## 5051-5053 FAUNTLEROY WAY SW

**Project #:** #3034217-LU & #3036305-LU

**Packet Type:** Design Recommendation

2 Solid Waste Storage Plan

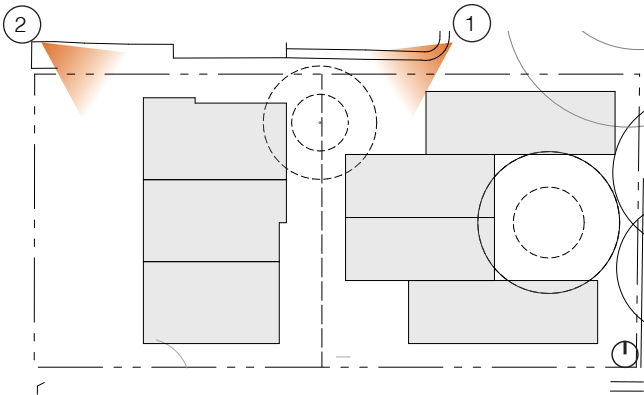
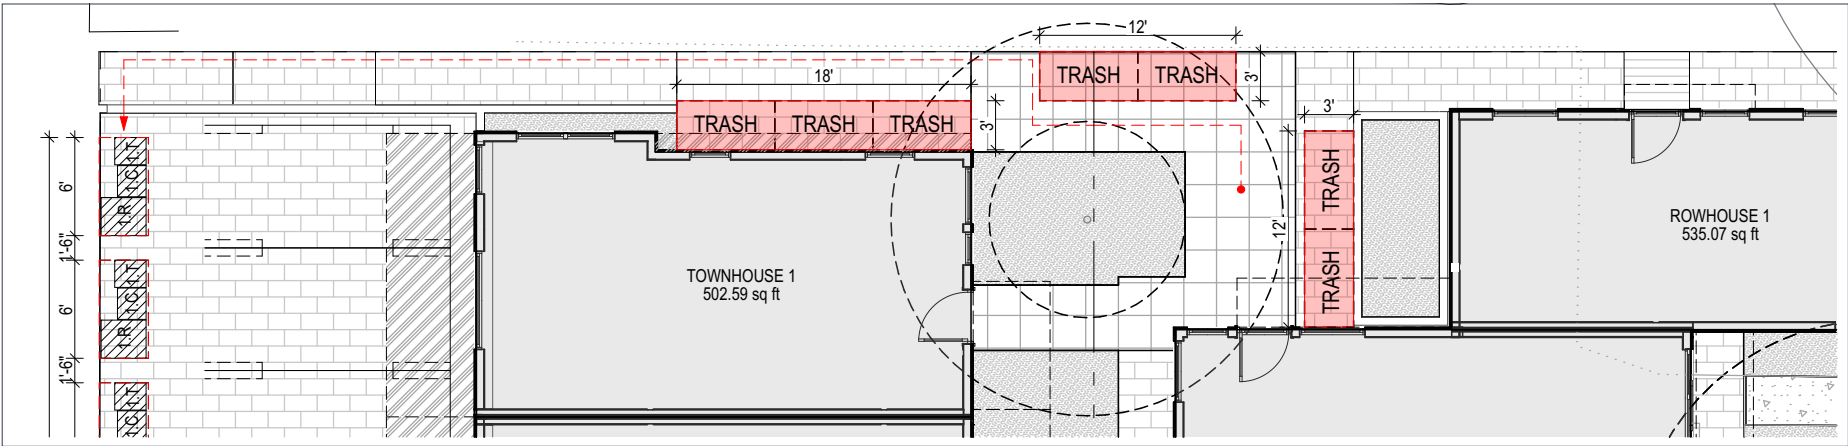
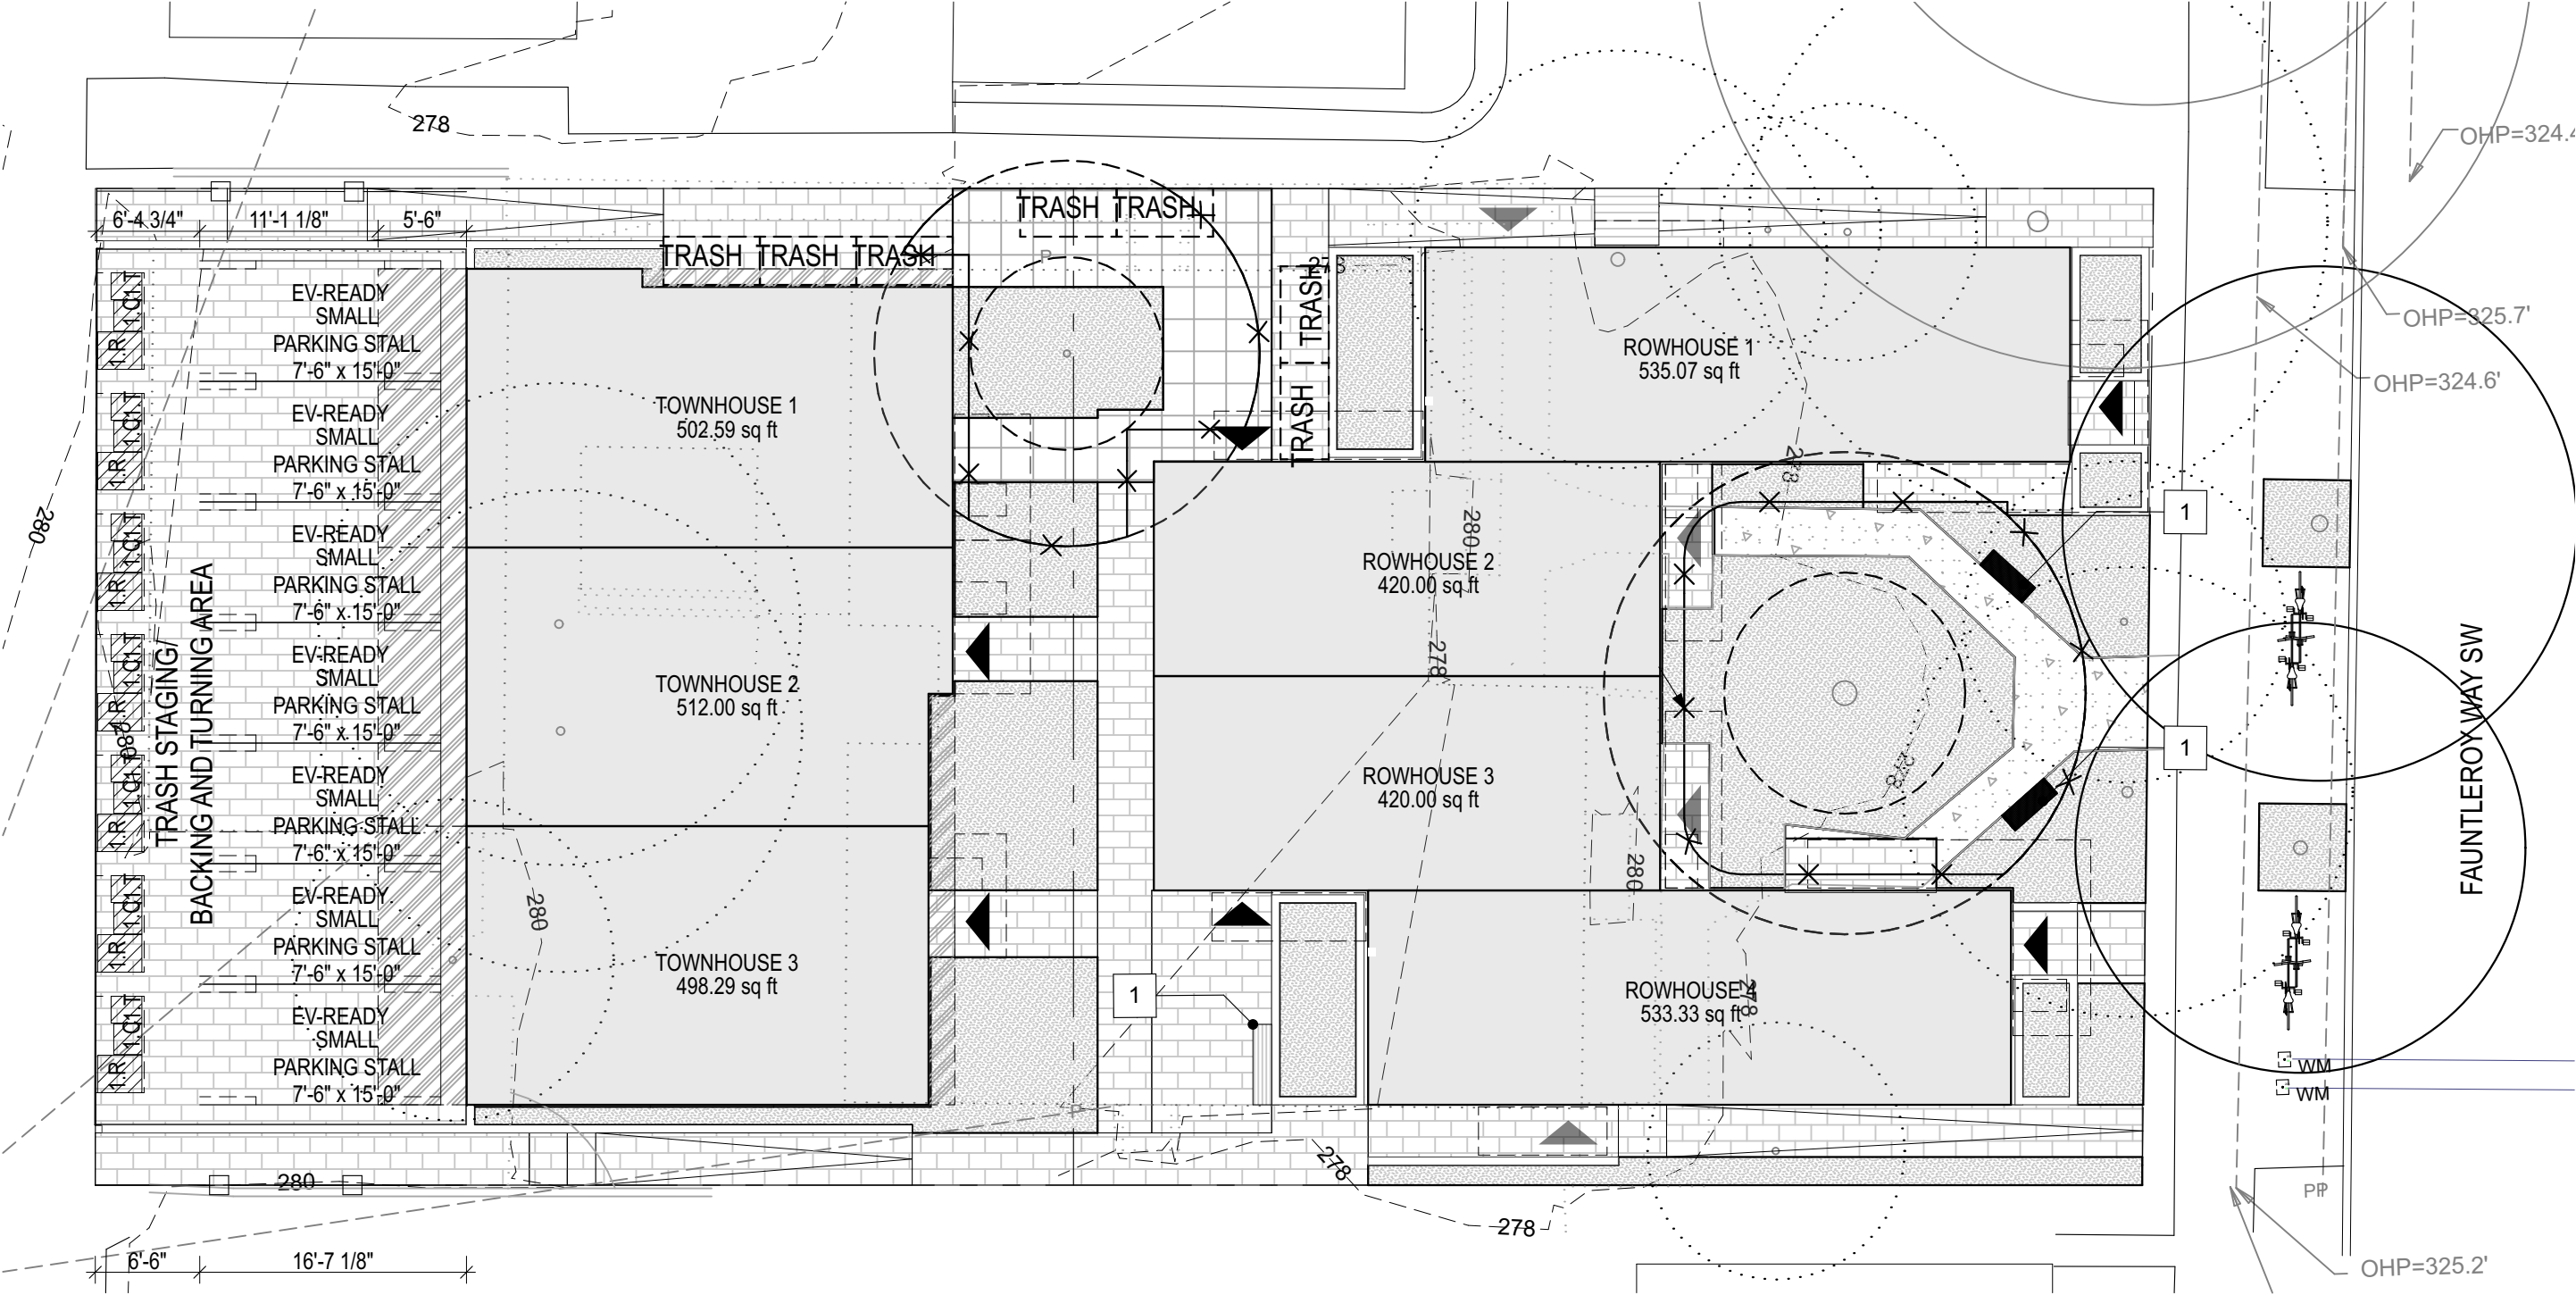
- a. **The proposed solid waste storage location is problematic. It is directly in front of three-unit entries and takes up a large amount of space in what could be an attractive courtyard. Explore other areas to house the solid waste storage that does not compromise other aspects of the project. (DC3-C-2)**

- b. **Revise the site circulation to provide a clear path to allow residents to move their solid waste from the storage area to the alley for collection without taking a roundabout path or trampling landscaping. (PL2-A-2)**

- The solid waste storage location has been revised in response to guidance. The first floor of Townhouse 1 has been reduced in size in order to accommodate the trash storage areas along the north facade of that unit. This creates a 6-foot setback at grade and provides ample space for a walkway that connects to the alley where trash will be staged for both properties along the alley property line. Trash storage for the Rowhouse site has also been revised, with storage for 3 units incorporated into a fence screening the courtyard from the adjacent property to the north and the fourth storage against the north wall of Rowhouse 2. This opened up an area at the north end of the properties allowing for an expansion of the courtyard. (DC3-C-2)

- Site circulation has been revised to provide a clear path for residents to move their solid waste to the alley area for collection. The path is located along the north side of the rear property to provide direct access without requiring walking over landscaping. This improvement results from reducing the ground floor of Townhouse 1 to provide an area for trash storage and walkway side by side in the north side setback. This design improvement results in a small departure request, to make all parking stalls small stalls. The backing and turning space is oversized to nearly 23 feet in response to the smaller stall. (PL2-A-2)
